SAM D09 Series Family Silicon Errata and Data Sheet Clarification

The SAM D09 Series family of devices that you have received conform functionally to the current Device Data Sheet (Atmel-42414G-SAM-D09-Datasheet_09/2016), except for the anomalies described in this document.

Data Sheet Clarifications

The following typographic corrections and clarifications are to be noted for the latest version of the Device Data Sheet (Atmel-42414G-SAM-D09-Datasheet_09/2016).

FIGURE 30-2: POR OPERATING PRINCIPLE:

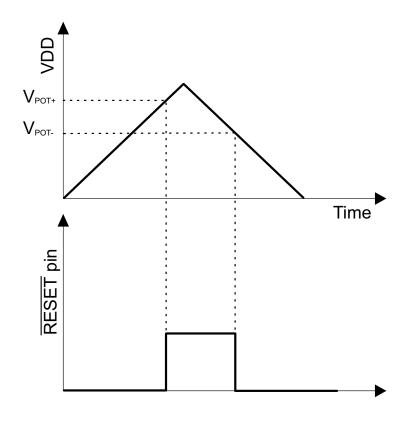
4. Module: Brown-Out Detectors (BOD) Characteristics

Figure 30-2, 30-3, and Figure 30-4 have an incorrect reset Polarity value. The corrected figures are as shown below:
